Tuesday, June 8, 2021
Medway Planning and Economic Development Board
155 Village Street
Medway, MA 02053

PUBLIC HEARING - GOOD FEELS MARIJUANA SPECIAL PERMIT MODIFICATION - 23 JAYAR ROAD

PUBLIC HEARING CONTINUATION - MEDWAY MILL SITE PLAN:

Figure 3. Barrier calculation for chiller with eight-foot barrier

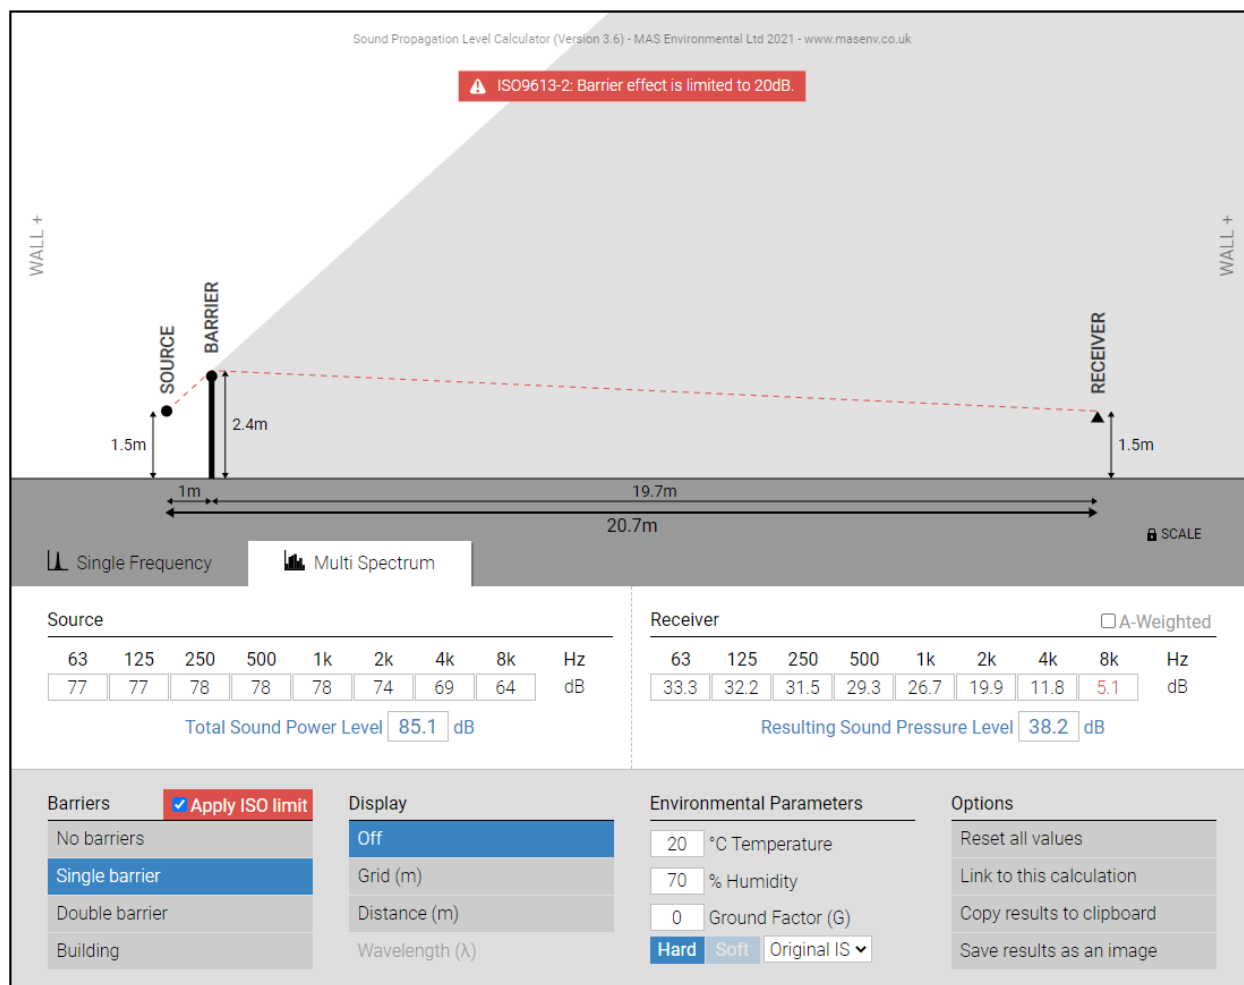
1. I see one for the chiller on Pg. 4 but don't see an equivalent figure using backup generator.
 2. Figure 3 on Pg. 6 (there's also a figure 3 on Pg. 4?) is labeled as generator with 8ft barrier but in the figure it shows a 4.3M (14ft) tall barrier and a distance to Jayar Rd not closest property line.
